Consulting Party for: New Yorkers For Wired Tech

December 26, 2023

**Re: Comments submitted for consideration in the matter of a Section 106 Review for  
Wireless Telecommunications Facility at 715 Columbus Avenue, New York, NY. Site  
name: MN-07-134709\_A (EBI reference #6123007682)**

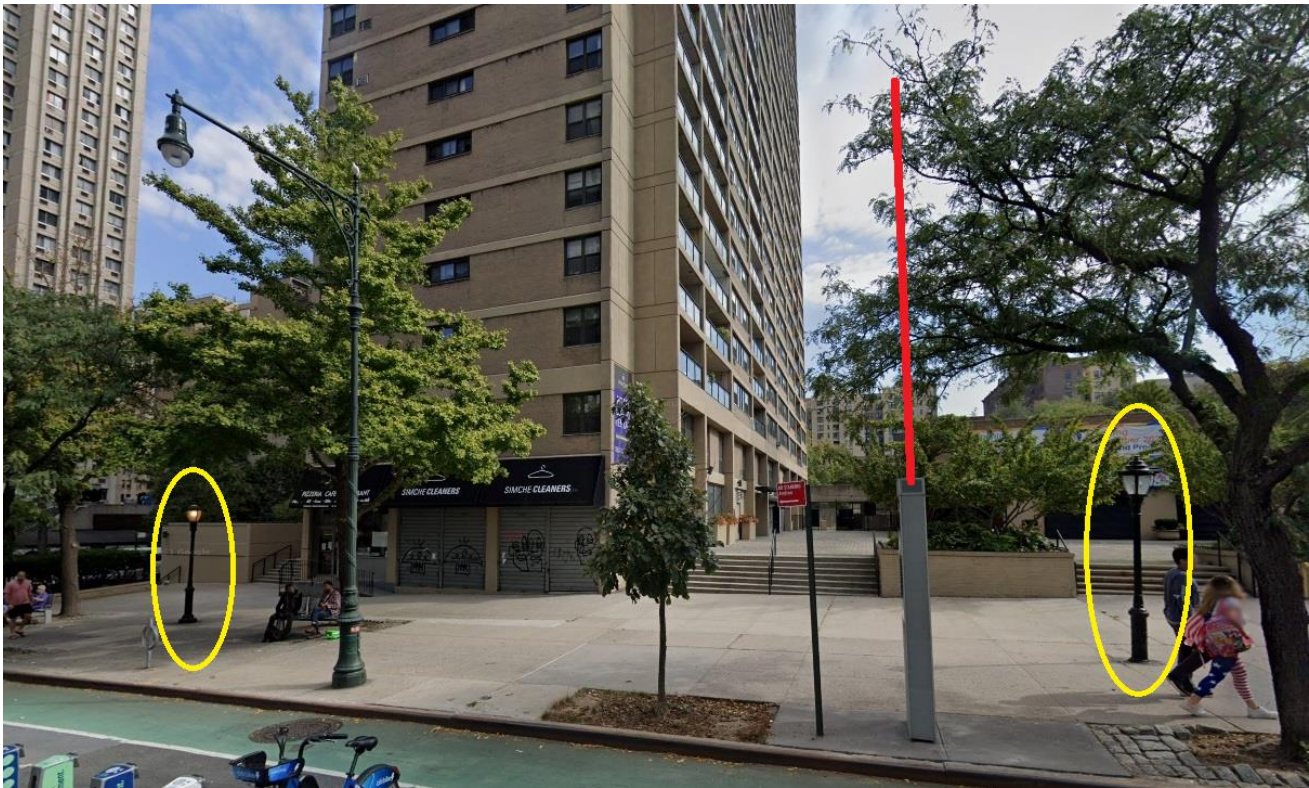
**Summary:** The proposed Link5G wireless facility (replacing an existing LinkNYC kiosk) at this site will introduce a massively oversized tower with an ultra-modernistic design that will create “visual adverse effects.” The 32’3” tower will diminish and alter the “setting” (including the landscape) in the “area of potential effects.” As discussed herein, the setting is clearly a character-defining feature of the nearby Upper West Side/Central Park West Historic District (UWS/CPWHD) that makes it eligible for listing on the Federal Register.

1. The applicant inaccurately asserts as sole criteria for determination of “no adverse effect” that Link5G tower must be visible from nearest resource.
2. The applicant disregards the “setting” along Columbus Avenue as a character-defining feature of the adjacent UWS/CPWHD that will be diminished by the Link5G tower.
  - Ornamental streetlight poles were a key element of the setting during period of historical significance - when the 9th Avenue El ran along Columbus Avenue.
3. The Applicant presents a misleading characterization of the current setting and streetscape by omitting any mention of multiple historically accurate reproduction streetlights and lamp posts in the “area of potential effects” (APE).

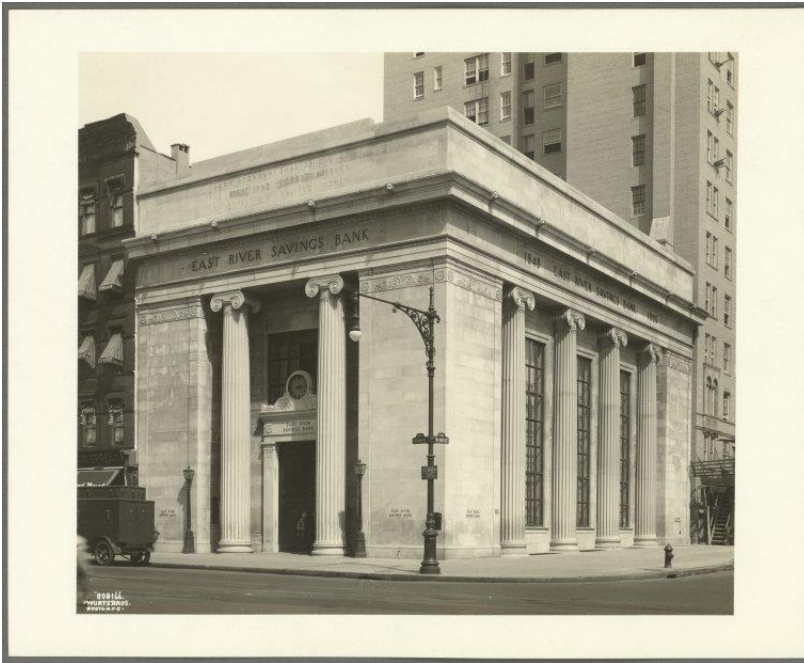
So, the fact is that both NYC DOT and the Public Design Commission as part of the reconstruction of Columbus Avenue took special measures to recreate a unique setting and feeling by the re-introduction of Type-M ornamental pole infrastructure along Columbus Avenue from West 59<sup>th</sup> to West 110<sup>th</sup> Streets. (While the standard paint color for the Type-M iron pole is black, the poles along Broadway are painted deep green.)

Image 9 – Map of Upper West Side showing 70 Type M streetlight poles along Columbus Avenue between West 88<sup>th</sup> and West 110<sup>th</sup>. The green star indicates the approximate location of the Project Site.

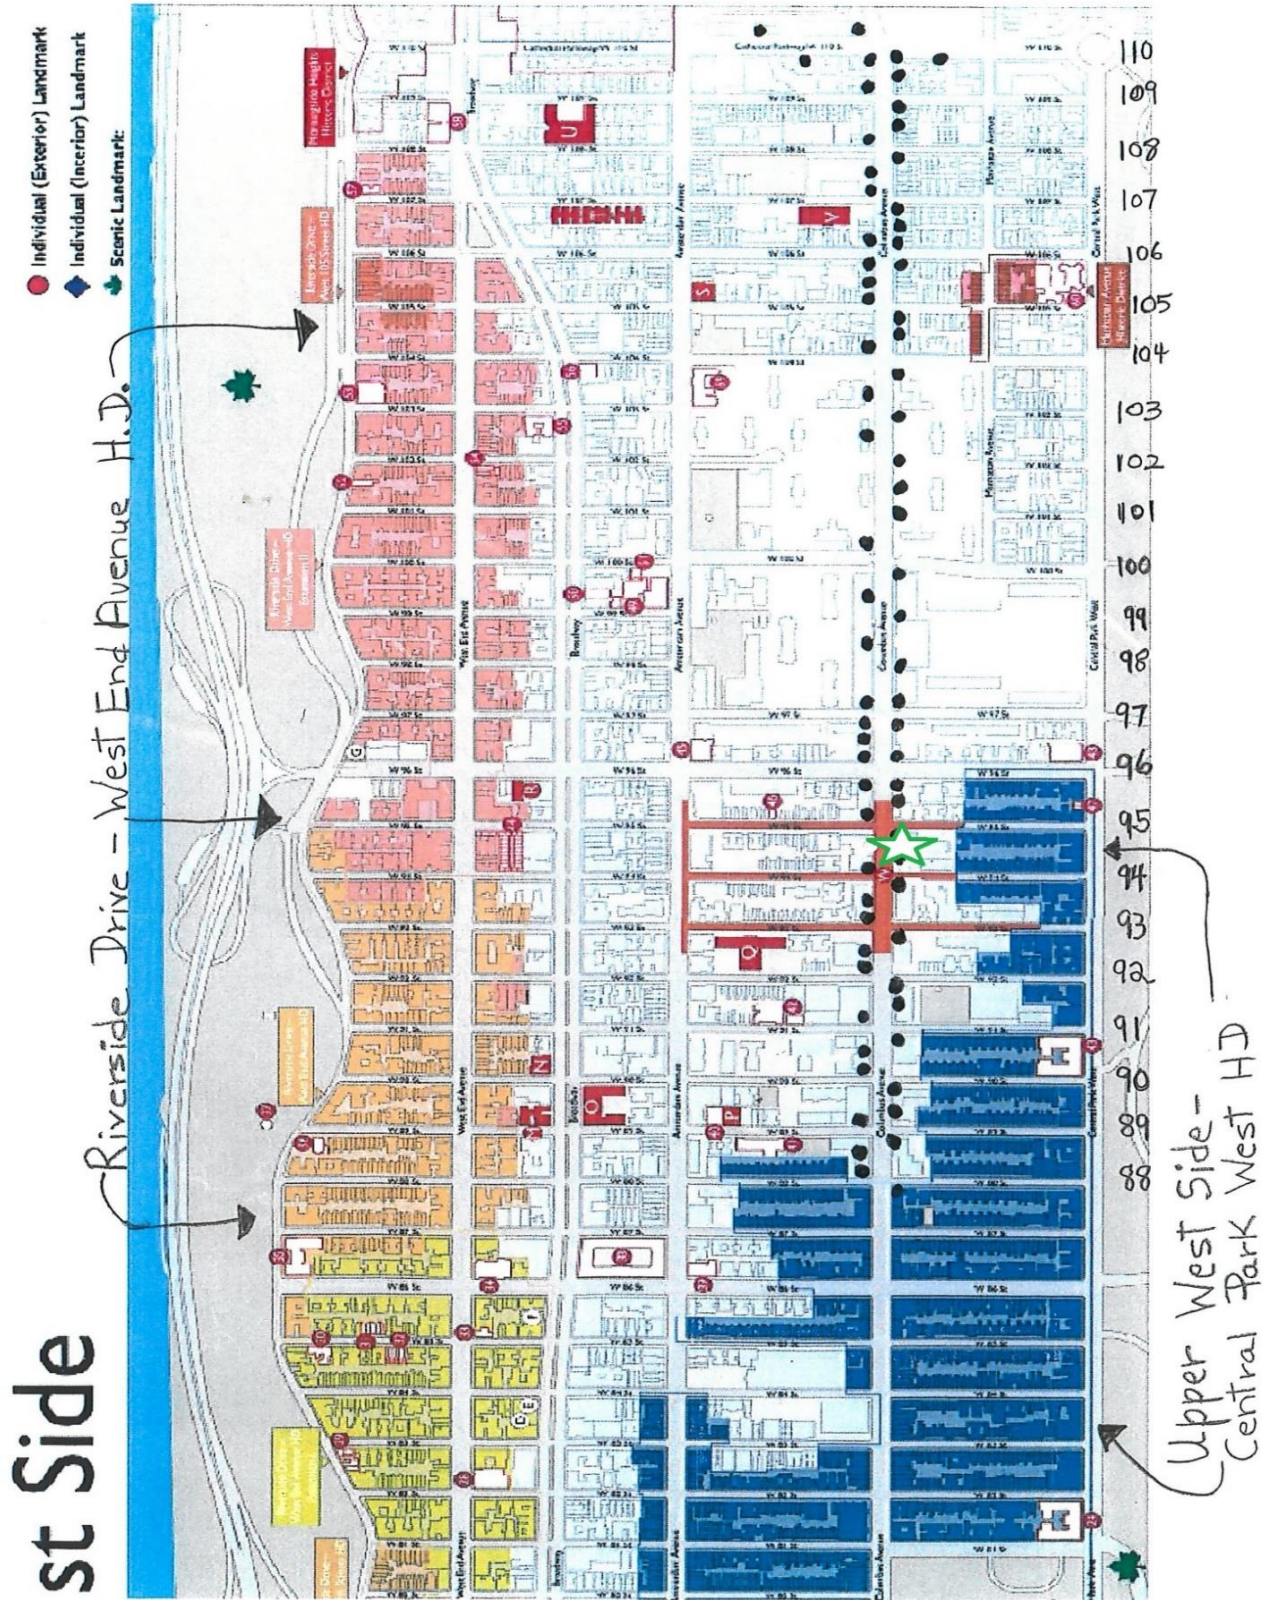
A walking survey of Columbus Avenue between West 88<sup>th</sup> and West 110<sup>th</sup> Streets identified no fewer than 70 Type M poles as indicated on the map (Image 9) below. Clearly, both the DOT and PDC have sought to create a parklike streetscape/setting in this area with historically accurate lighting elements and ample vegetation to better connect with designated and eligible historic district and resources within the APE.<sup>14</sup>

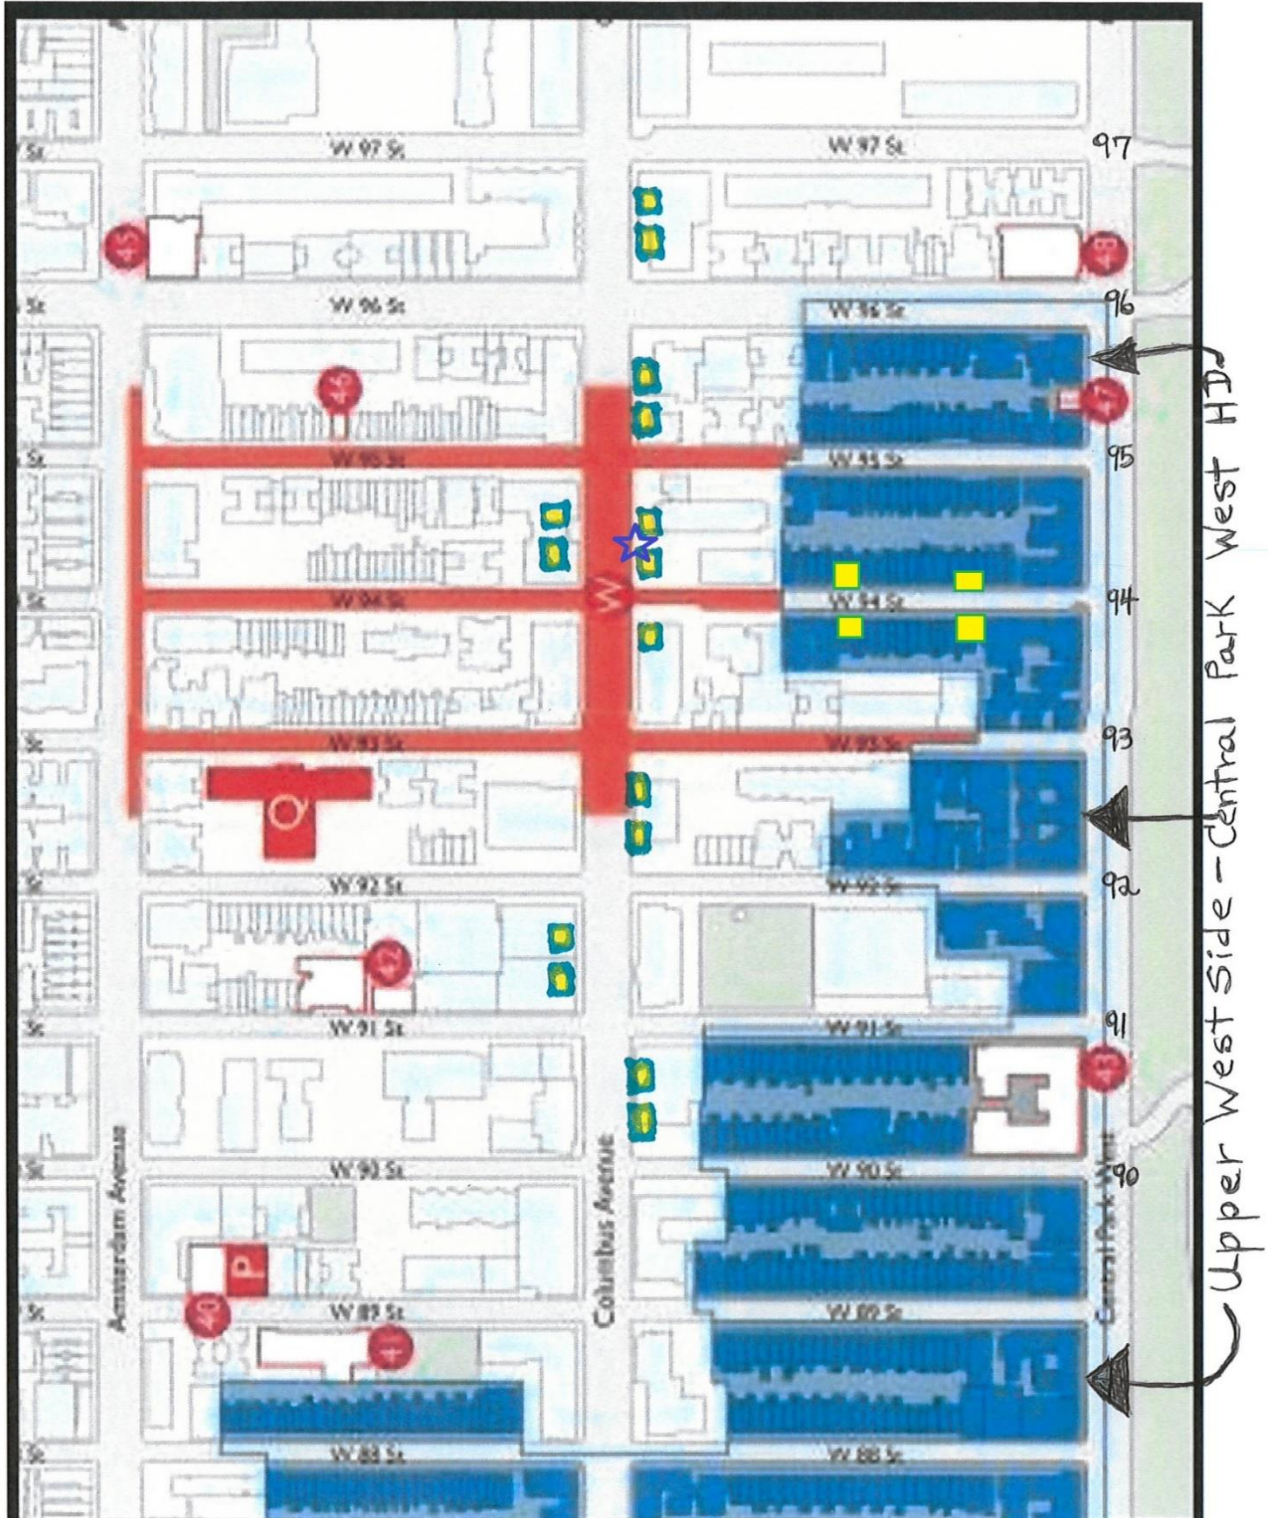
As mentioned above, NYC DOT apparently took additional steps as part of the reconstruction of Columbus Avenue by also installing historically accurate reproduction pedestrian lighting. As mentioned above, there are two distinctive Type B Pedestrian poles sited mid-block just a few yards from the proposed Project Site as shown in Image 1 above. (Two more Type B poles are located across the street in front of the Walgreens and the Post Office store fronts at 700 Columbus Avenue.) As the map shows in Image 10 below, these four lampposts are part of more than 15 such Type B lampposts placed on Columbus Avenue sidewalks between West 90<sup>th</sup> and West 97<sup>th</sup> Streets. Once again, these Type B poles, like the Type M's, represent major undertakings by NYC DOT to improve the feeling and association of the setting within the APE of the Upper West Side/Central Park West Historic District.

The applicant shows a photo of the historically accurate reproduction Type B (Pedestrian) pole in Photo 5 on page 36 of Form 620. But inexplicably the applicant offers no narrative to identify this Type B luminaire, pole, and base. (Photo 6 in the Form 620 also shows the Type B but the entire lamppost is almost totally obscured by scaffolding.)
